APPLICATION NO.	FILING DATE	FIRST NAMED INVENTOR	ATTORNEY DOCKET NO.	CONFIRMATION NO.
10/633,496	08/05/2003	Ben Hsu	BHT-3125-156	5199

Office Action Summary

DETAILED ACTION

*Fig. 3.**Fig. 1.**Fig. 2.**Fig. 4.*

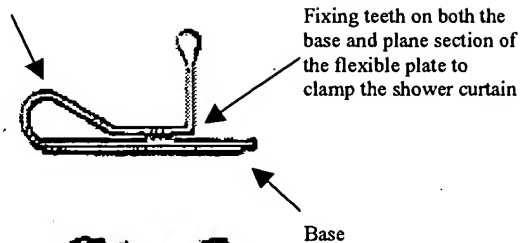
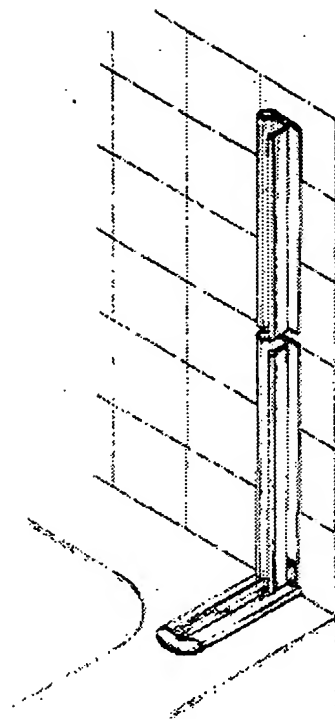
Olson (figures 1-3, 8) teaches a side hook for a shower curtain, mainly made up of a fixing clip having a base and an arc flexible plate disposed at the other side thereof in clamping abutment with the base thereof wherein a clamping passage is defined at the bottom ends of the base and the arc flexible plate there-between for both lateral sides of a shower curtain to be pushed there-through for clamping location at the fixing clip therein.

One having ordinary skill in the art would recognize that Olson suggests an adhesive layer on the base to secure it to the shower stall wall. The differences are that it is not stated that the flexible plate is resiliently pressing against a first surface of the base and the connector portion is curved rather than flat and perpendicular to the base. However, Wear (figure 4) teaches clip structure for sheet material including a base 11, a flexible plate 12 having a first surface resiliently pressing against a first surface of the base (col. 1, line 65 - col. 2, line 4; reproduced below), a flat connector portion connecting a first end of the base and a first end of

FIG. 5

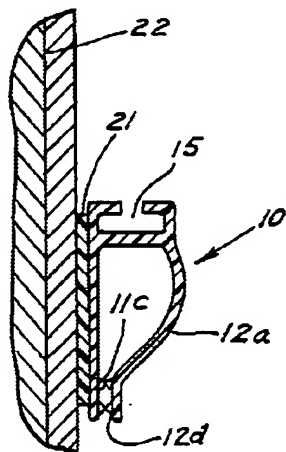
the flexible plate, the flat connector portion extending perpendicularly from the first surface of the base, and a clamping passage located between a second end of the base and a second end of the flexible plate. A self-adhesive interface 21 mounts the clip to a support surface.

Said front wall from the point of engagement there- 65
with of said horizontal wall 14 is shown having a bulg-
ing outward downward and inward curvature as at 12b
terminating in a bottom vertical flange portion or strip

12c which is parallel with an opposing lower edge por-
tion 11a and the same have a natural normally resilient
and yielding gripping engagement. The curvature of
said front wall enhances its gripping action.

As it would be beneficial to enhance the gripping action of the shower curtain clip of Olson, it would have been obvious to modify the shower curtain clip of Olson such that the flexible plate is resiliently pressing against a first surface of the base and the connector portion is flat and perpendicular to the base in view of Wear et al. teaching such structure as being advantageous in securing sheet material. As to claim 6, Wear et al. suggests the use of a curved flexible plate as enhancing the gripping action and this renders obvious the modification of the shower curtain clip of Olson to have such subject matter. In regard to claim 7, applicant specifically states in the response to the election requirement received September 20, 2004 that "Applicant submits that claims 6, 7 and 9 are also generic to both species" (page 2, ¶2, lines 3-4). Based on this statement, claim 7 covers applicant's figure 6 which is described in the specification on page 5, ¶2 as reproduced below:

FIG. 5

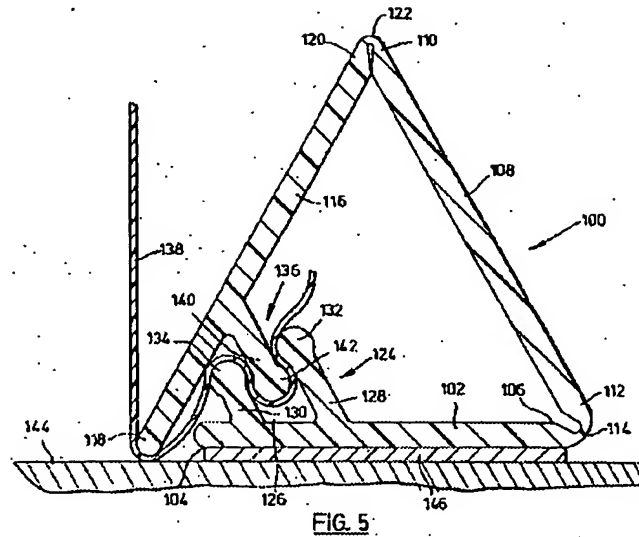
Further modification of the shower curtain clip of Olson such that a double-sided adhesive tape is used on the base to secure it to the shower stall would have been obvious in view of one having ordinary skill in the art would recognize that Olson suggests an adhesive layer on the base to secure it to the shower stall wall and Cairns (figure 5) teaching fixing clip

structure 100 for a shower curtain 138 wherein it is advantageous to utilize double-sided adhesive tape 146 for ease of assembly.
